## Product / Process Change Notification (PCN)

**PCN #:** PCN\_IndPD\_20181008

**Affected Series:** WE-PD-Series  
 744778xxx  
 744777xxx

In line with the adoption of industry standards, Würth Elektronik will change the shrink tube material from PVC to PET to reduce the content of halogen afflicted materials.

Current: PVC Tube	New: PET Tube
 <p data-bbox="592 584 695 629">PVC</p>	 <p data-bbox="1235 584 1339 629">PET</p>
Finished Good	Finished Good

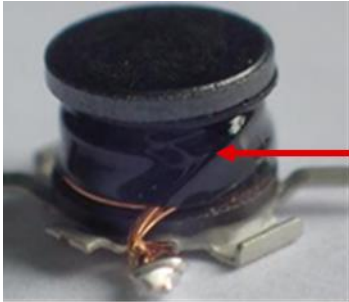
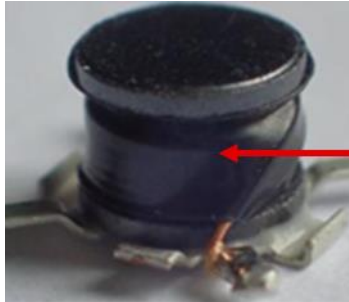
It is necessary to protect the wire isolation from further production steps. The shrink tube is covering and protecting the winding.

To meet international environmental requirements Würth Elektronik is changing the tube from PVC to PET material. The PET material is not containing any substances which are forbidden by RoHS, Reach or Halogen Free standards.
